Pentium[®] Pro Processor Specification Update

Release Date: June, 1997

Order Number: 242689-019

Figure 4-3. Stack Switch on a Call to a Different Privilege Level

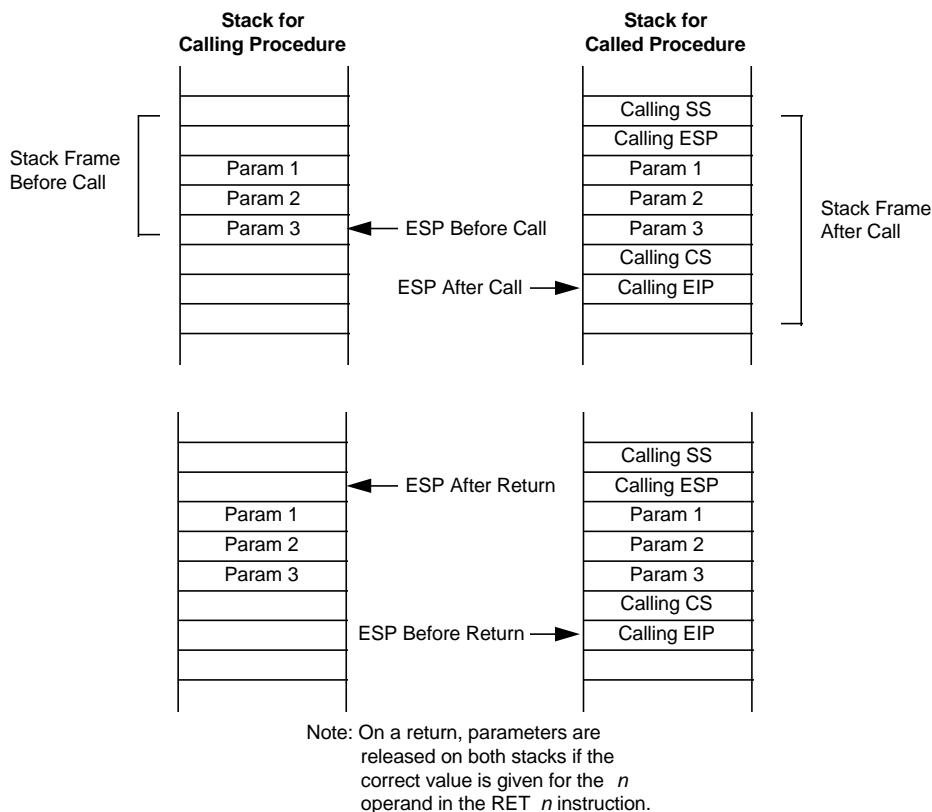
When making a call to a more privileged protection level, the processor does the following (see Figure 4-3):

Figure 4-4. Stack Usage on Transfers to Interrupt and Exception Handling Routines

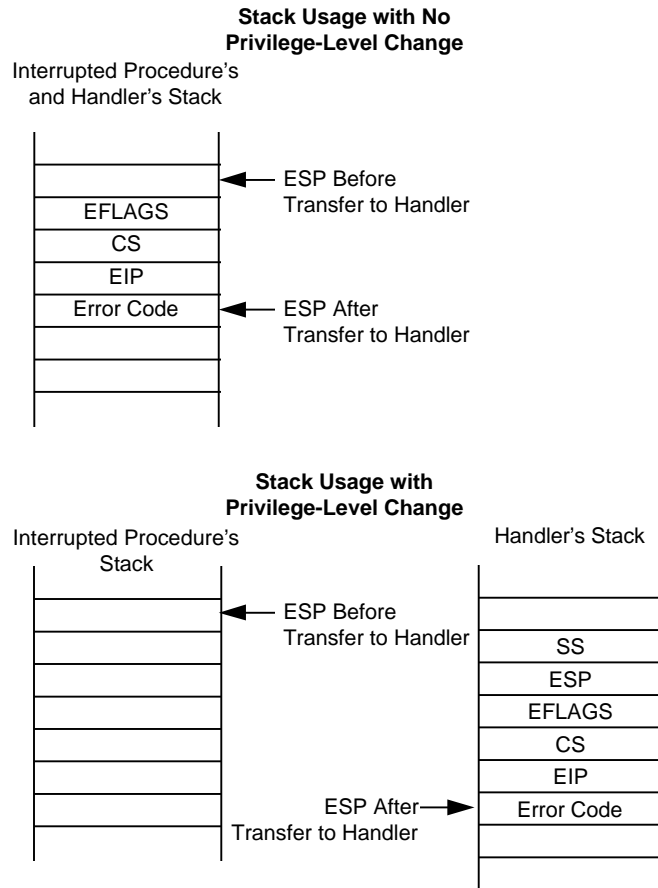
If no stack switch occurs, the processor does the following when calling an interrupt or exception handler (see Figure 44):
